**SECTION 905 -- PROPOSAL (CONTINUED)**

**PROJECT: NH-0021-01(066)/107699301 - Marshall**

**SECTION 904 -NOTICE TO BIDDERS NO. 2213**

**SUBJECT: Advance Warning Flashing Assembly**

**PREPARE TO STOP WHEN FLASHING ASSEMBLY (VERTICAL)**

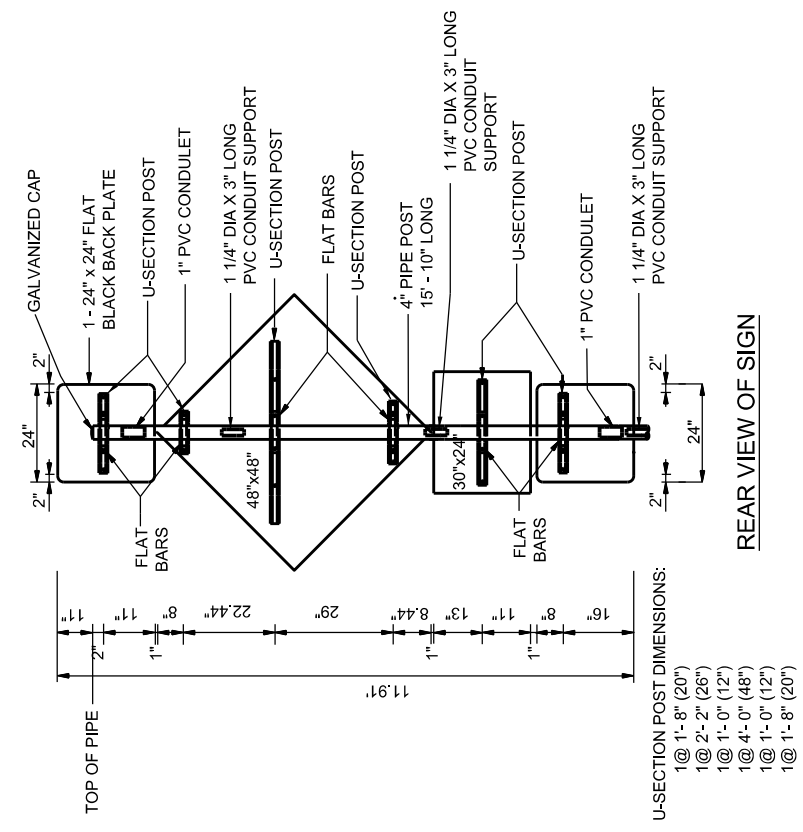
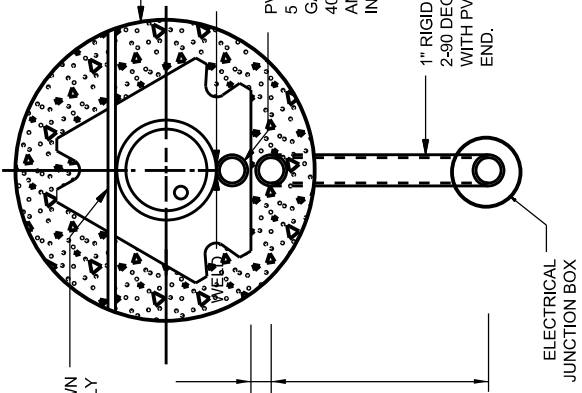
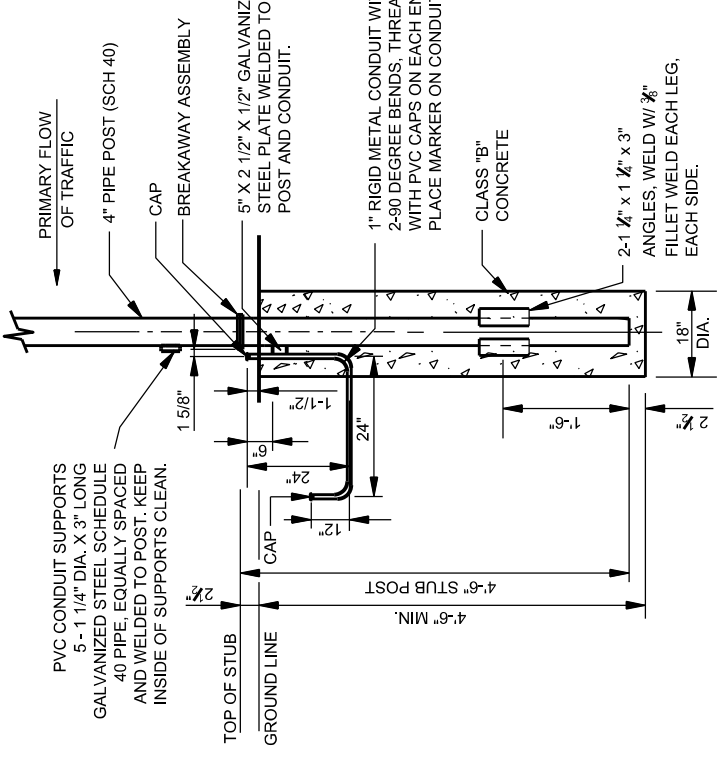
Bidders are hereby advised that the “Prepare to Stop When Flashing Assembly” shall be in accordance with the attached drawing.

USE 2 - 5/16" X 1 1/2" ZINC COATED BOLTS TO ATTACH 2.0 LB/LF U-SECTION POSTS TO THE FLAT BARS ON THE 4" PIPE POST. USE 4 - 5/16" X 3" ZINC COATED BOLTS TO ATTACH SIGNS/BACKPLATES TO THE 2.0 LB/LF U-SECTION POSTS.

- NOTES:
1. ELECTRICAL JUNCTION BOX TO BE PLACED FLUSH WITH GROUND.
  2. ALL ABOVE GROUND WIRING SHALL BE ENCLOSED IN 1" PVC CONDUIT WITH A BREAK-A-WAY CONNECTION AT THE POST. WIRING FROM THE CONDULET INTO THE FLASHERS SHALL BE ENCLOSED IN PVC FLEX PIPE.

3. THE WIRING SHALL INCLUDE A WATERPROOF FUSE IN THE JUNCTION BOX AND A WATERPROOF CUT-OFF SWITCH AT THE METER.
  4. THE INSIDE OF THE CONDUIT SUPPORTS SHALL BE CLEAN AND FREE OF WELD.

5. THE TWO FLASHERS ON THE FLASHER ASSEMBLY SHALL ALTERNATE ON AND OFF WHEN RECEIVING A SIGNAL FROM THE TRAFFIC CONTROLLER. THE FLASHER ASSEMBLY SHALL HAVE BEACONS THAT FLASH AT A RATE OF NOT LESS THAN 50 OR MORE THAN 60 TIMES PER MINUTE. THE ILLUMINATED PERIOD OF EACH FLASH SHALL NOT BE LESS THAN 50% OF THE DWELL TIME. THE YELLOW SIGNALS SHALL BE FLASHED ALTERNATELY. THE BEACONS SHALL HAVE A NIGHT DIMMING FEATURE.

7. FLASHER HEADS WITH 12" YELLOW LENS REQUIRED.
  8. EACH FLASHER HEAD SHALL BE MOUNTED TO A FLAT BLACK SIGN BLANK (24"X24"X0.080") BACKPLATE USING 2 - 5/16" X 1 1/2" ZINC COATED BOLTS MOUNTED INSIDE THE LENS HOUSING.
